SERVICE LETTER NUMBER 144			
TITLE: DRAG STRUT ATTACHMENT, WASHER REPLACEMENT			
BY: R. GLASS	AIRCRAFT MAKE/MODEL(S):	FLOAT MODEL(S):	NOTE(S):
APP: J. SORTOR	FIREBOSS	10000	MANDATORY COMPLIANCE
DATE: 18-JAN-16	AIR TRACTOR 802 & 802A		S/L P/N 1005968
REV: B			ECO-24216

This service letter applies to all S/N 10126A and prior Wipline model 10000 amphibian floats, as installed on "Fireboss" Air Tractor 802 and 802A aircraft. This service letter applies to Air Tractor 802/802A aircraft equipped with STC SA01795CH.

Figure 1: Attachment Location (Strut Fairings Removed)

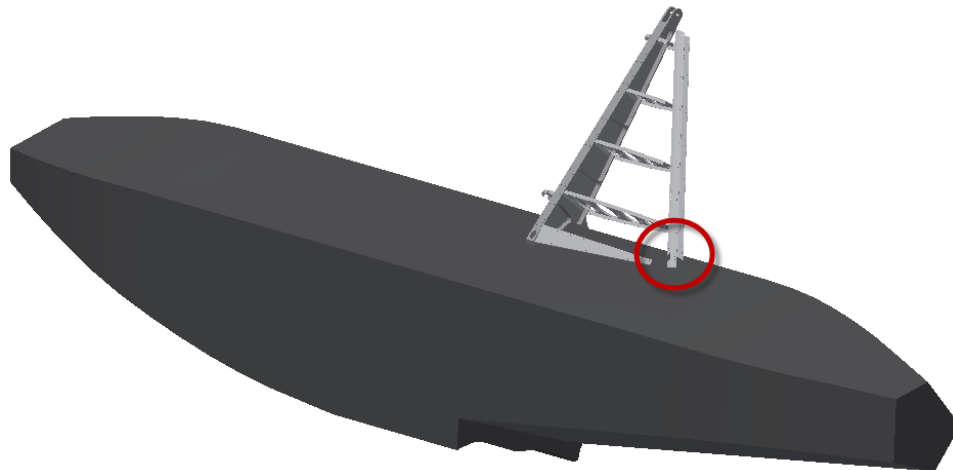
The bolted attachment of the drag strut to the float has been found to cause coning of the flat washers both under the bolt head and the nut. Deformation of the washers in turn results in a loose bolted attachment.

NOTES: Figure 1 shows the attachment location in question and Figure 2 details the hardware replacement that must be made.

1. Position aircraft safe for maintenance.
2. Provide for support of float and remove Drag Strut attachment nut, bolt, and washers.

Note: Inspect drag strut attach point for hole elongation. If hole is found to be elongated, comply with service letter 145 (P/N 1005968).

Figure 2: Hardware Replacement Detail

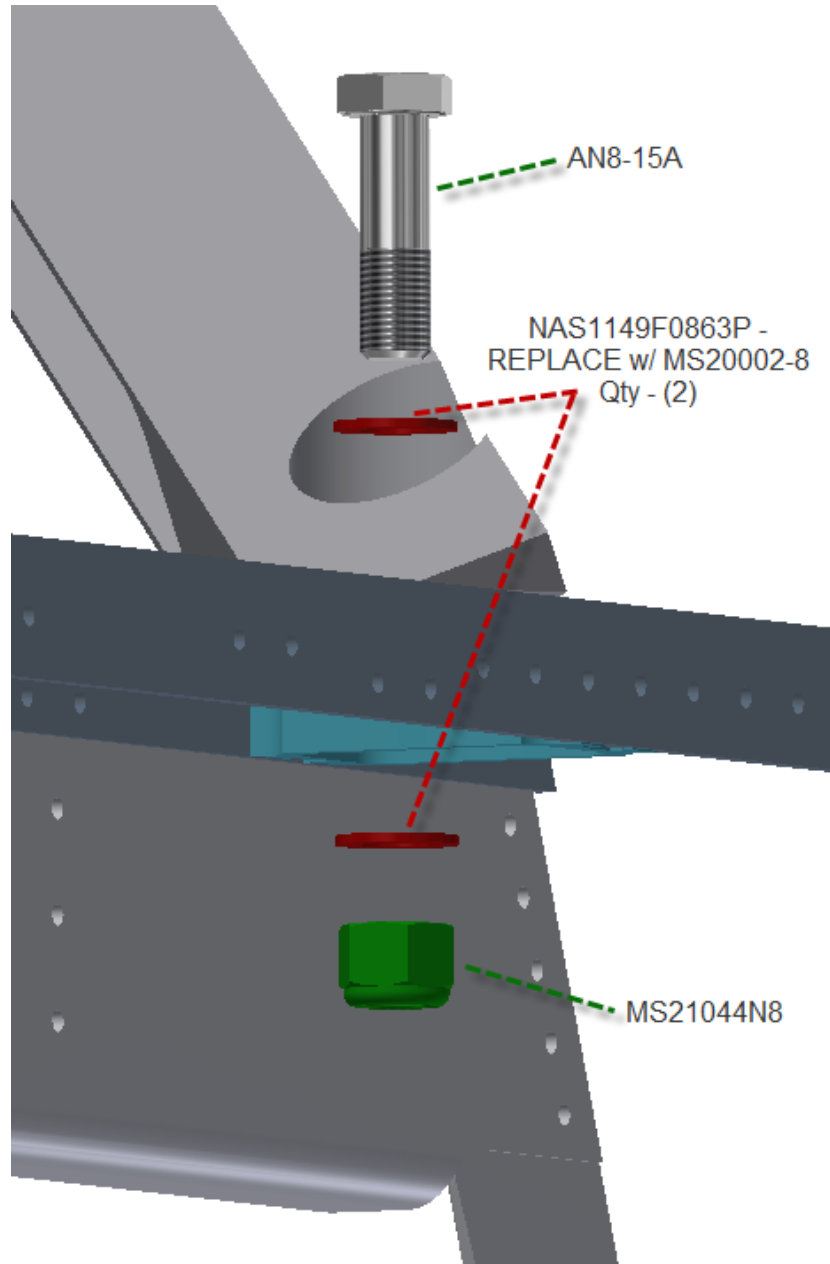
Removal and replacement of the two (2) standard NAS1149F0863P flat washers in the float to drag strut attachment with high strength MS20002-8 plain washers.

3. Replace existing NAS1149 washers with MS20002 washers and reinstall bolt. Re-torque to 480-690 in-lbs (40-57.5 ft-lbs).
